Australian Resources Development Pty Ltd

Submission regarding GenCost 2022-23 Consultation draft

16 February 2023

Diagrammatic depiction of the GenCost integration methodology

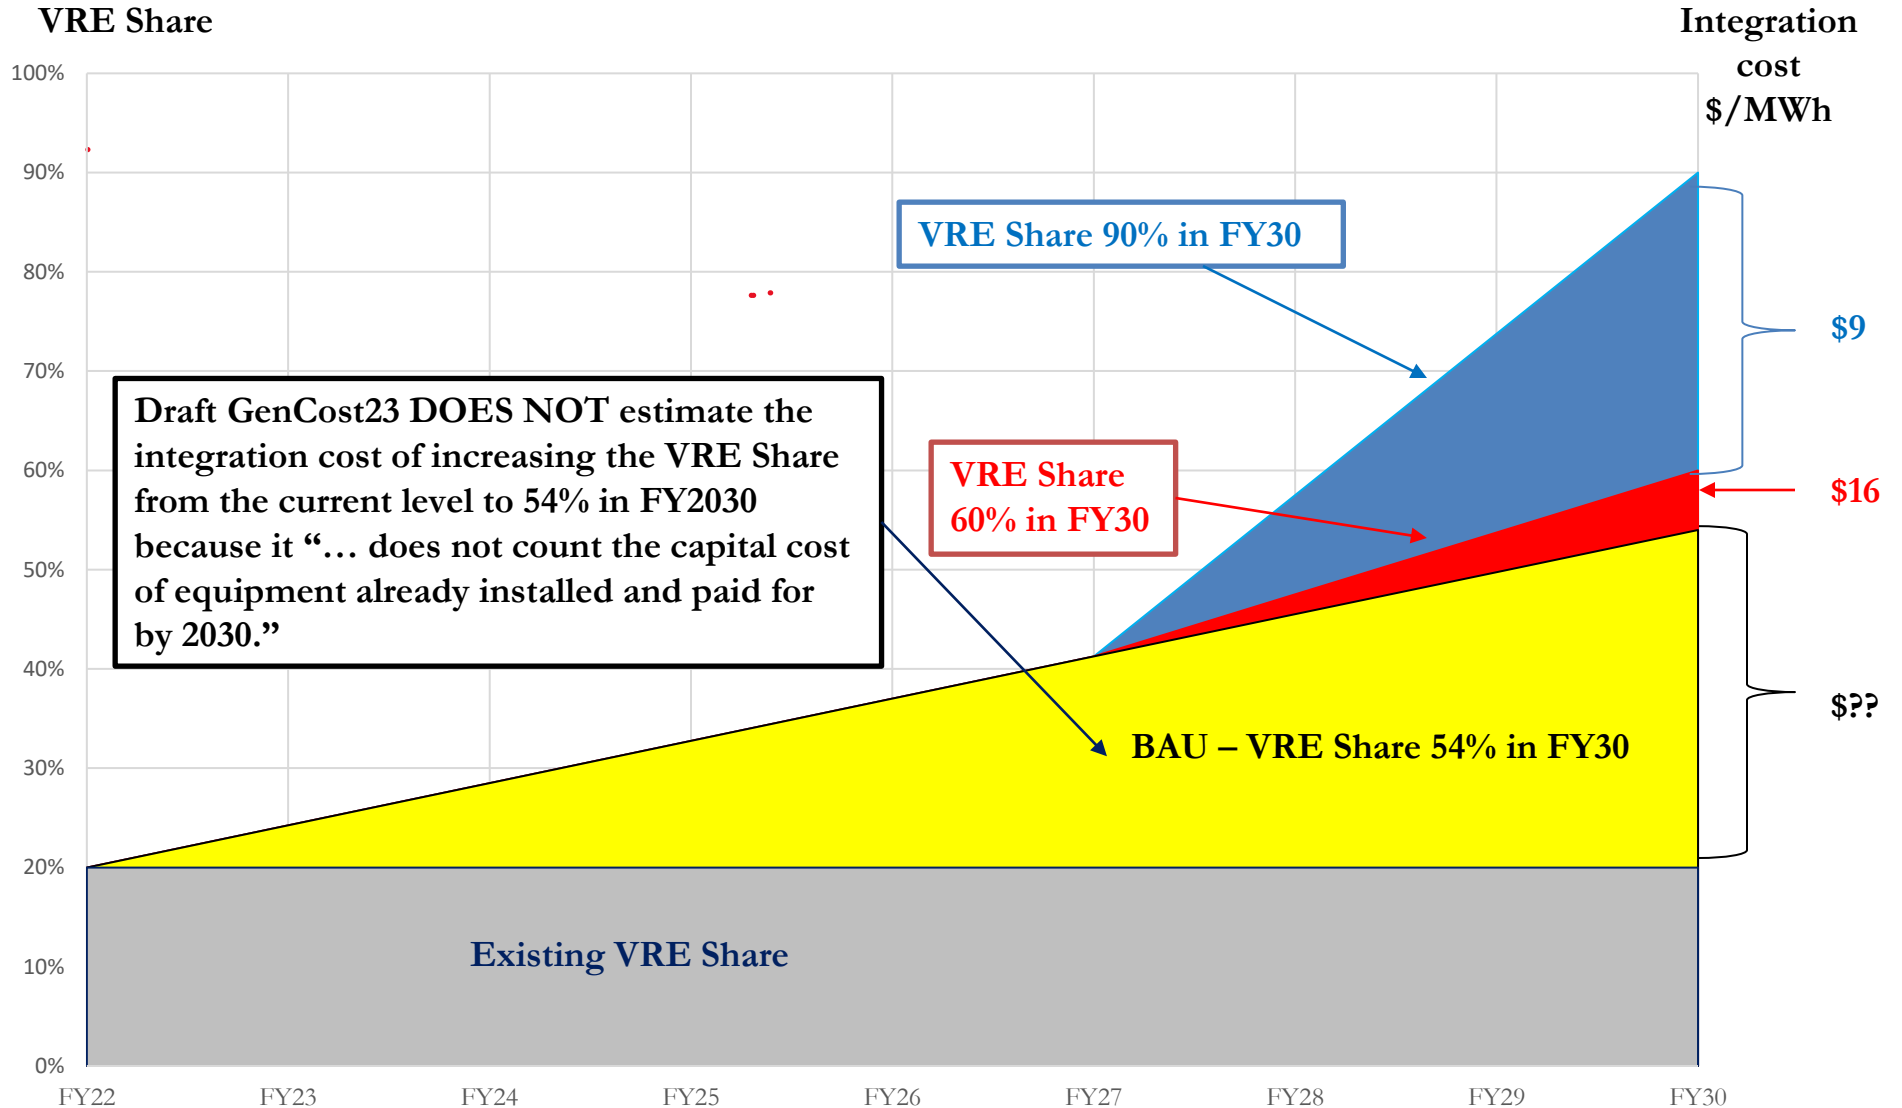
The GenCost methodology only applies to the cost of integrating additional VRE capacity in FY2030 ABOVE the 54% VRE generation share (**VRE Share¹**) projected in the business as usual (**BAU**) case in FY2030. That is, the methodology DOES NOT measure the cost of integrating additional VRE capacity above the current level of approximately 20% in FY2022 to approach 54% in FY2030. The methodology is depicted in the following Slide.

Thus, the GenCost results are of little relevance to the major issue TODAY - what is the integration cost to maintain a reliable system while increasing the VRE Share from the current level to 54% by FY2030?

The final GenCost23 report could reduce the confusion by fully explaining its results by extending its conclusion as follows:

The analysis confirms that, when integration costs are included, variable renewables remain the lowest cost new-build technology AS THE PENETRATION OF VRE GENERATION RISES ABOVE 54% IN 2030. IN THIS CONTEXT, INTEGRATION DOES NOT EQUATE TO FIRING THE ADDITIONAL RENEWABLE CAPACITY REQUIRED TO INCREASE THE PENETRATION OF VRE GENERATION FROM THE CURRENT LEVEL TO 54% IN 2030.

The confusion could be eliminated in the final GenCost23 report if the integration methodology was extended to include the total cost of maintaining a reliable system as the VRE Share increases from the current level to 54% in FY2030. Under this approach, integration would effectively equate to firming, apart from the capital cost attributable to plant already installed by FY2022. If these additional costs are included, the integration cost is approximately \$60/MWh to achieve a 54% VRE Share by FY2030.

Diagrammatic depiction of the GenCost integration methodology

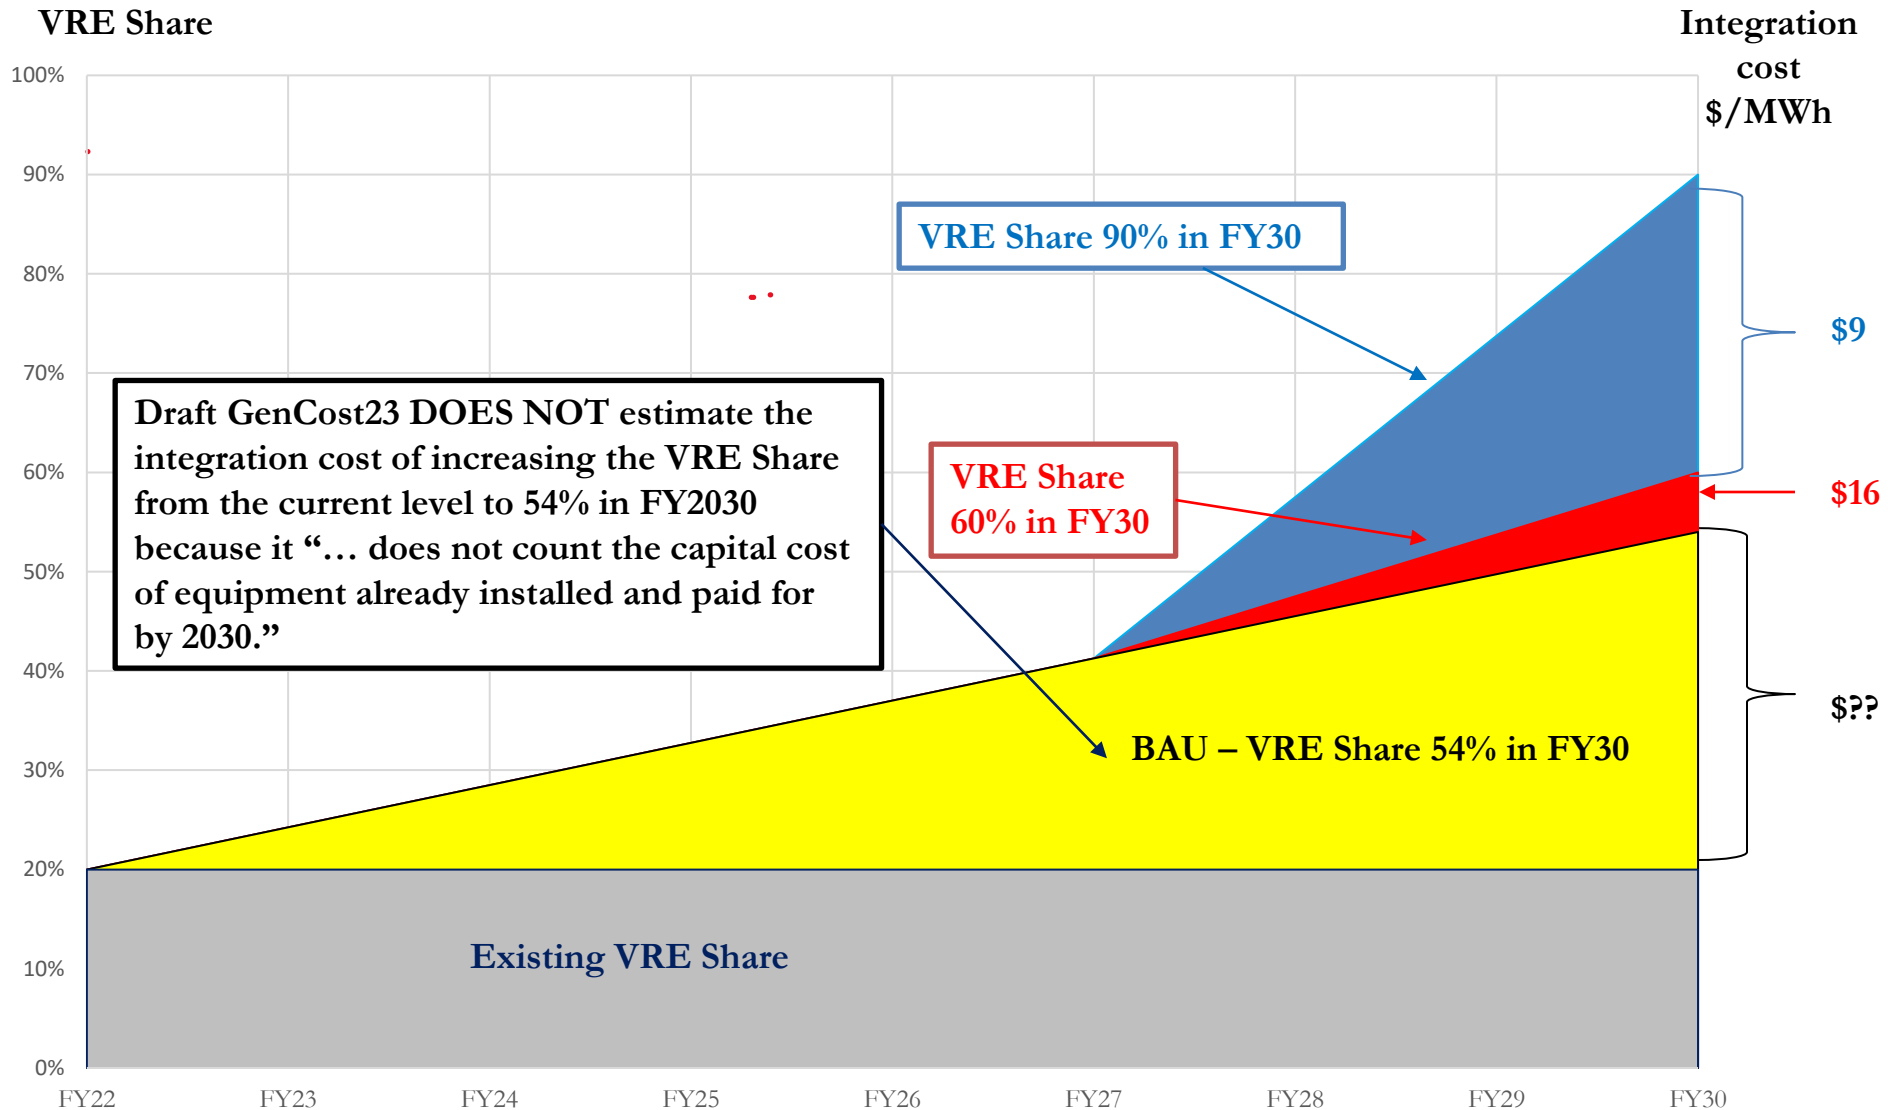
This diagrammatic depiction demonstrates that the GenCost integration methodology only measures the cost of integrating the additional VRE capacity in FY2030 above a 54% VRE Share. That is, the methodology DOES NOT measure the cost of integrating the additional VRE capacity required to increase the VRE Share from its current level of approximately 20% in FY2022 to 54% in FY2030. This very narrow definition of the incremental VRE integration cost above a future level is of little relevance to the major issue TODAY - what is the integration cost to reach a 54% VRE Share in FY2030 from current levels?

Thus, as currently defined, INTEGRATION is not FIRMING as it fails to take account of the cost of reaching the BAU VRE Share of 54%.

One way the final GenCost23 report could reduce the confusion is by clearly explaining the results as follows:

The analysis confirms that, when integration costs are included, variable renewables remain the lowest cost new-build technology AS THE PENETRATION OF VRE GENERATION RISES ABOVE 54% IN 2030. IN THIS CONTEXT, INTEGRATION DOES NOT EQUATE TO FIRING THE ADDITIONAL RENEWABLE CAPACITY REQUIRED TO INCREASE THE PENETRATION OF VRE GENERATION FROM THE CURRENT LEVEL TO 54% IN 2030.

The confusion could be eliminated in the final GenCost23 report if the integration methodology was extended to include the total cost of maintaining a reliable system as the VRE Share increases from the current level to 54% in FY2030. Under this approach, integration would effectively equate to firming, apart from the capital cost attributable to plant already installed by FY2022.
